PrintServer 17/600 Printer

Maintenance Advisory

EK-PRT17-MA. A01

This maintenance advisory describes how the PrintServer 17/600 printer differs from the PrintServer 17 printer and provides new, corrected, or updated information for the PrintServer 17 Printer Service Guide.

Figure 2-1 New V2.1 Controller Board Test Patterns

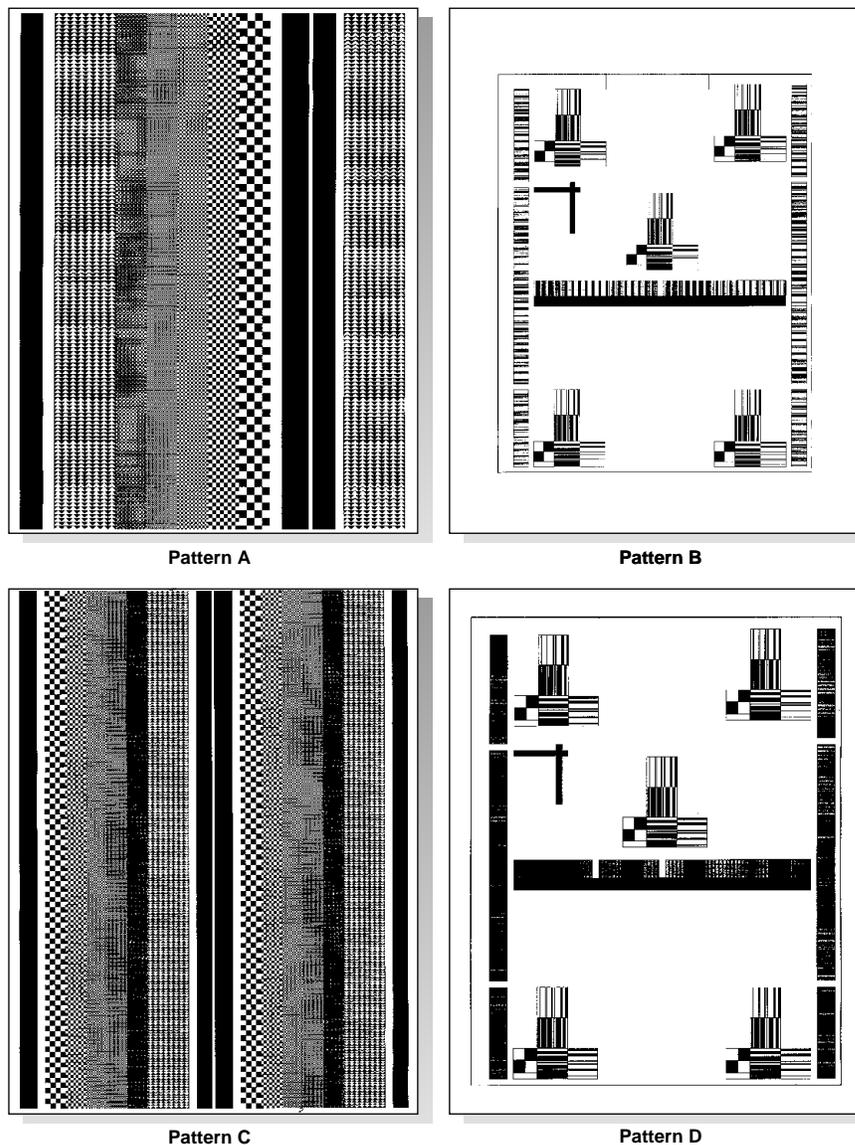
Figure 2-1 shows the 400 and 600 dpi test patterns that are printed by a PrintServer 17/600 printer. An example of the PrintServer 17 300 dpi pattern appears in Figure 4-2 of the service guide.

- Patterns A and B are printed at 400 dpi. Compare the B and D test test patterns. Notice how the B pattern is smaller on the page than pattern D. This only happens at 400 dpi.
- Patterns C and D are printed at 600 dpi. Compare the C and the A test patterns. Notice how the C test pattern is horizontally compressed. This compression effect increases as the density (dots-per-inch) increases.
